# Access Compliance Report

## Public Rights-of-Way

### (Pedestrian Signals)

Intersection ID: N/A	Main Street:	Cross Street: N/A	Location: N/A
ADA ID: DF3607515C19	Signal Type: One Push Button-Non APS	Overall Compliance: No	Severity Score: BTN 1: N/A BTN 2: N/A No BTN: N/A
Codes/Mitigation Info/Possible Solution		Field Measurements/Component Compliance

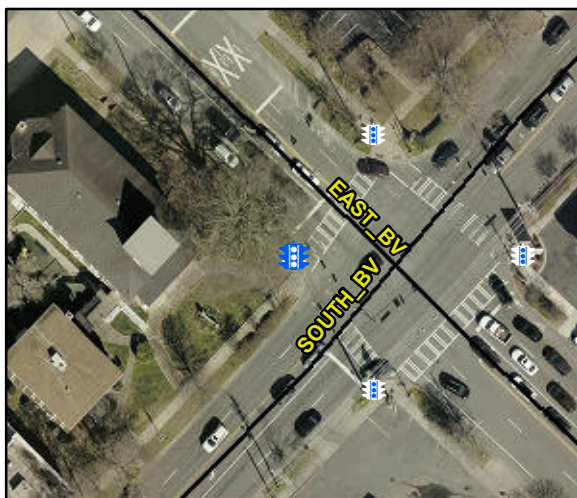
PROW/ADA: R404.2, R404.3, R406.2

Possible Solutions: Provide Push Button Extension. Remove and Replace Clear Space.
